Project Name	Hastings Secondary College Port Macquarie • PCYC		
Project Code	HSPM		
Revision	Date	Comment	Approved
0	23/11/21	Facade Clarifications	EC

# Request for additional information

## 18/11/21

West Elevation

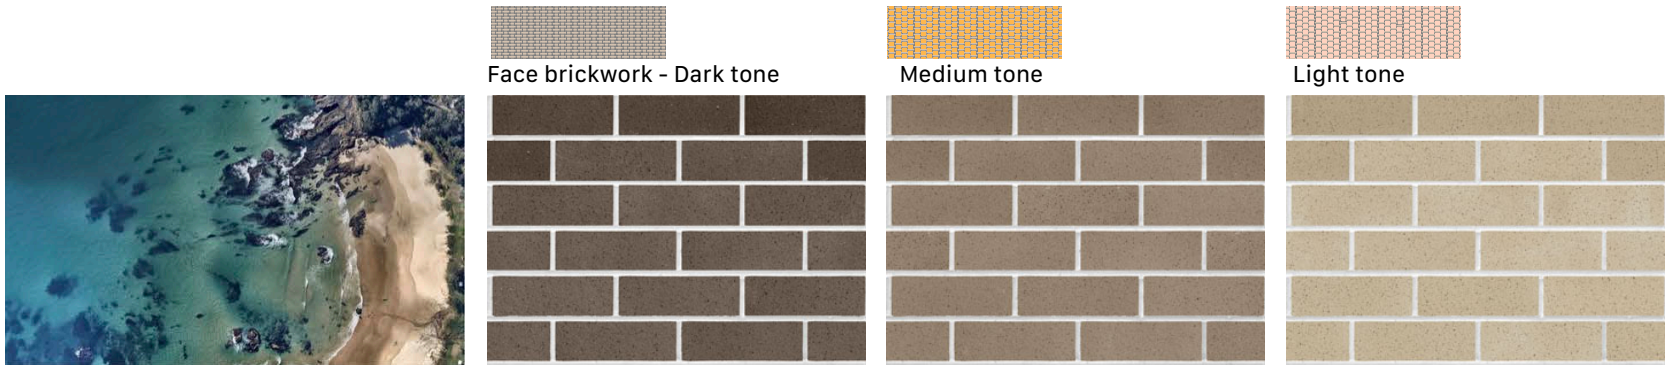
Brick detail specification:  
Flemish bond typically.  
Soldier course around window opening .  
Header bricks finish flush, recessed, protrude or are open to the pattern identified in the elevations.
